Re: DART+ West Railway Order - Dublin City to Maynooth and M3 Parkway

Re: DART + West Electrified Railway Order 2022

Third Party Observation ref. CIE / Irish Rail works to railway tracks

Illustration of Works - Ballybough Bridge

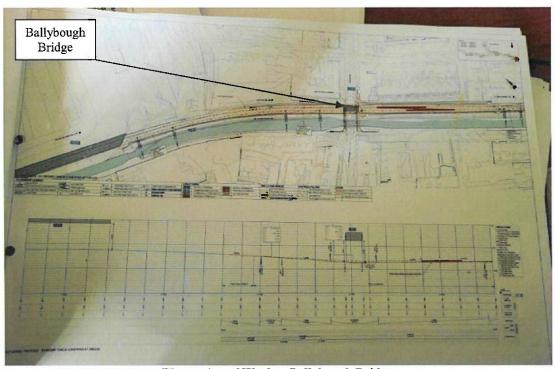
The existing southern railway line under Ballybough Bridge will lowered by approximately 150-300mm below the existing track level.

Illustration of Works - Russell Street Bridge

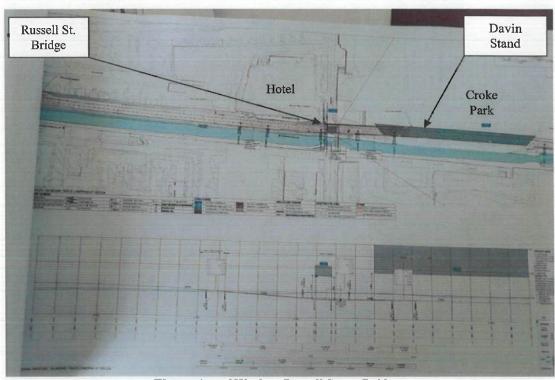
The same railway line under Russell Street Bridge will be reduced by approximately 240mm. This will also involve the realigning of the tracks under the Davin Stand and on the track south of the Hotel.

Portion of map illustrating permanent acquisition of Love Lane

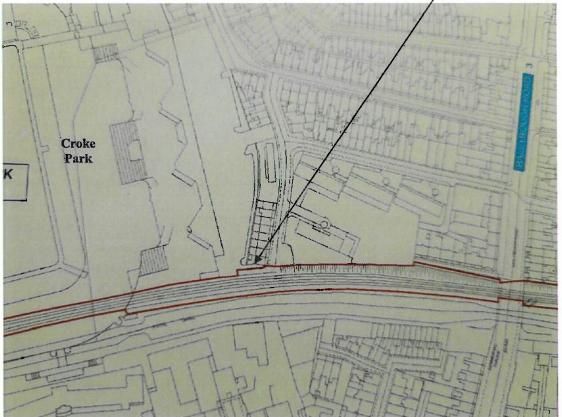
There is some confusion in that one description of the works talks about a temporary acquisition of the Love Lane area in order to facilitate reinforcement of the boundary treatment. However, a further drawing (LAN15102) illustrates a permanent boundary extended beyond the Love Lane area. I suspect that the latter is an error but nonetheless this needs to be confirmed with CIE.

A second issue relates to the question of whether there is a permanent or temporary acquisition of Love Lane.
